AMENDMENT OF SOLICITATION/MODIFICATION OF CONTRACT				1. CONTRACT ID CODE	PAGE 1	OF PAGES 32
2. AMENDMENT/MODIFICATION NO. 0002		3. EFFECTIVE DATE SEE BLOCK 16B		4. REQUISITION/PURCHASE REQ. NO. WA-09-00278		5. PROJECT NO. (If applicable)

Solicitation No. DTFWA-08-ACEPS
Amendment 002, dated October 22, 2008 (continued)

**ARTCC CRITICAL ESSENTIAL POWER SYSTEM (ACEPS) BATTERY REPLACEMENT QUESTIONS WITH
ANSWERS TO SIR/RFO DTFWA -08-ACEPS**

Figure 1. ACEPS Battery Room Generic Layout and Configuration.

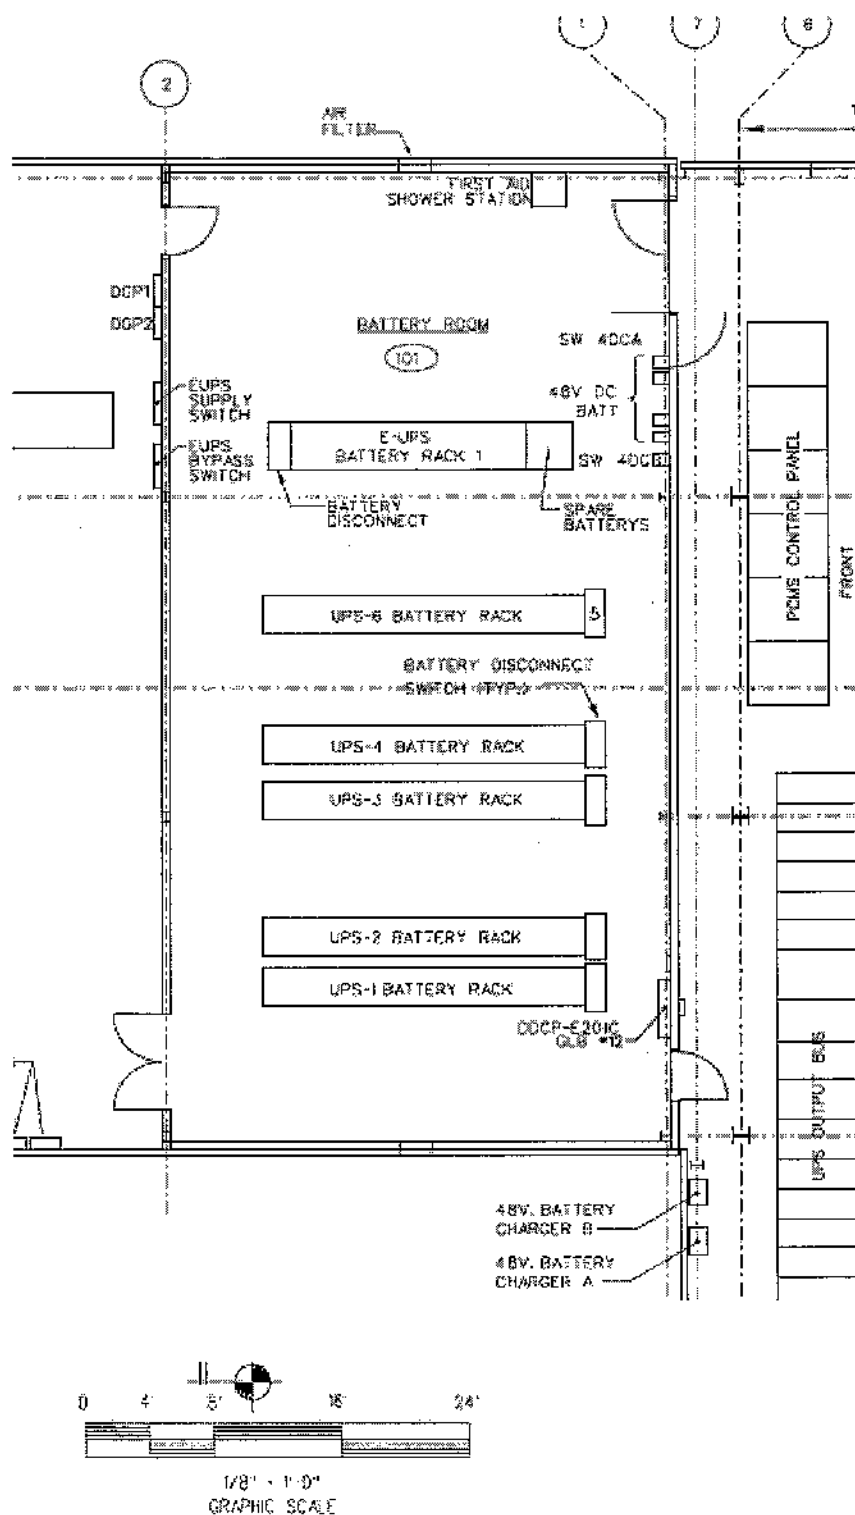
58. **Q:** Do you have an ACEPS battery room drawing?
A: See Figure 1 on page 9 for a standard battery room configuration. This is a generic battery room layout. Each site will have differences, such as, room width; access door locations; and DC disconnects on opposite side of battery string; and numbers of battery strings in each room; etc..
